13 February 2019

Local Planning Panel

Development Application: 79-83 Abercrombie Street, Chippendale

File No.: D/2018/947

Figure 9: Amended outdoor dining area

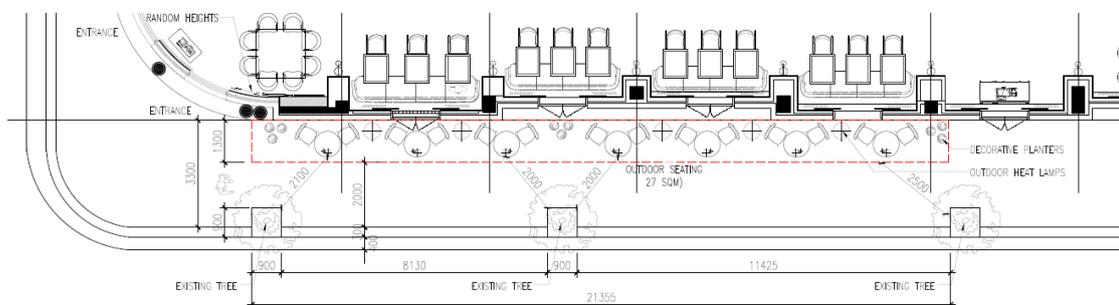
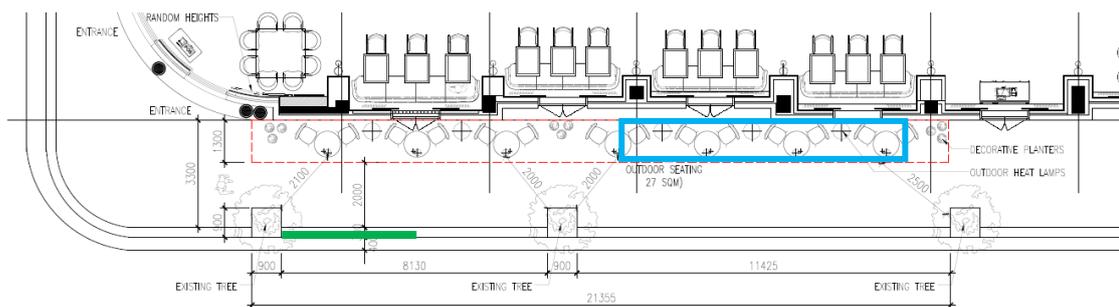
24. The pedestrian crossing is pictured in Figure 4 and is located at the green line shown in Figure 9. Provision 3.3 of the guidelines states in areas of high pedestrian volume, Council may not allow outdoor dining if not suitable. As per the guidelines, it is important to maintain safe, dignified and equitable access to the pedestrian crossing for all pedestrians and other uses travelling along the street.

25. It is recommended approval is not given for outdoor dining located adjacent the pedestrian crossing as there is not adequate space for pedestrians. Reducing the proposed outdoor dining area will ensure an unobstructed path of travel from the footway to the crossing for all pedestrians, including pram-users or disabled pedestrians. The amendment of the outdoor dining area to ensure a consistent, 2m clear path of travel, is also supported by Council's Public Domain unit.
